Job 23-4836-R01	Truss R18RP1	Truss Type MONOPITCH	Qty 24	Ply 1	LOT 19 PROVIDENCE CREEK   TBD COTTON SEED LANE FUQUAY-VARIN
Atlantic Building Components, Moncks Corner, South Carolina					Job Reference (optional)

## REPAIR(S) REQUIRED

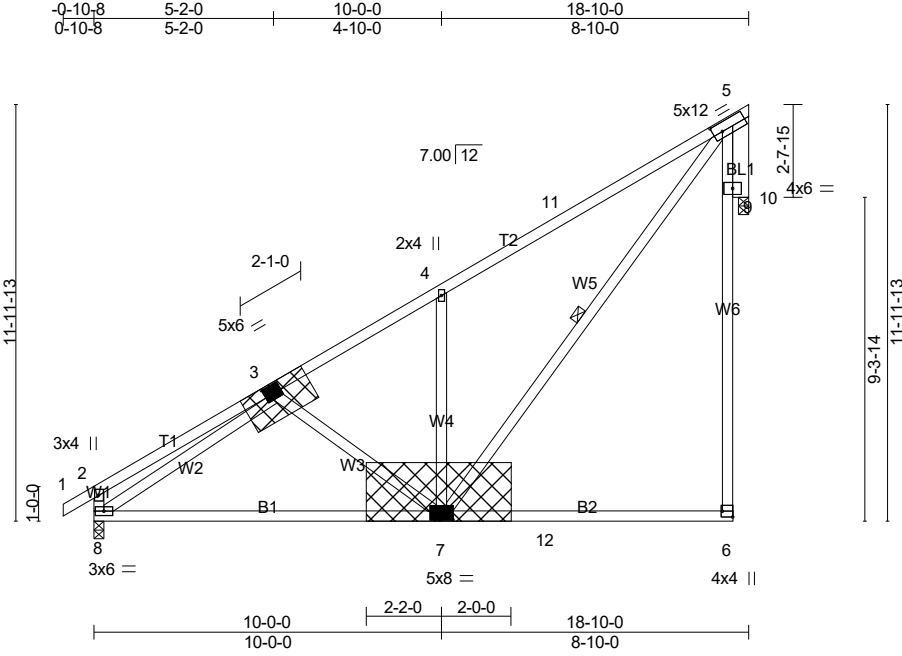
- NOTES-** (13-16)
- 1) Repair Condition: Missing diagonal web 3-7 with damaged plate(s) on both side(s) of truss at joint(s) 7,3.
  - 2) Attach 21"H X 50"W X 3/4" Plywood or OSB (23/32" APA Rated Sheathing 48/24 Exposure 1) gusset to both sides of truss at joint 7 with 10d (0.131"x3") nails from each face, driven through both sheets of plywood. Connected together as follows: 2x4 - 2 rows 0-4-0 o.c. Minimum 0-3-0 end distance.

- 3) Attach 13"H X 25"W X 7/16" OSB (APA Rated Sheathing 24/16 Exposure 1) gusset to both sides of truss at joint 3 with 10d (0.131"x3") nails from each face, driven through both sheets of plywood and clinched. Connected together as follows: 2x4 - 2 rows 0-6-0 o.c. Minimum 0-3-0 end distance.

- 4) Remove any remaining fragments of missing web 3-7 and replace missing with same size and grade material cut to fit tight.
  - 5) Wind: ASCE 7-16; Vult=120mph (3-second gust) Vasd=95mph; TCDL=5.0psf; BCDL=5.0psf; h=23ft; Cat. II; Exp B; Enclosed; Gable Roof; Common Truss; MWFRS (envelope) gable end zone and C-C Exterior(2E) -0-10-8 to 3-11-2, Interior(1) 3-11-2 to 18-2-12 zone; C-C for members and forces & MWFRS for reactions shown; Lumber DOL=1.60 plate grip DOL=1.60
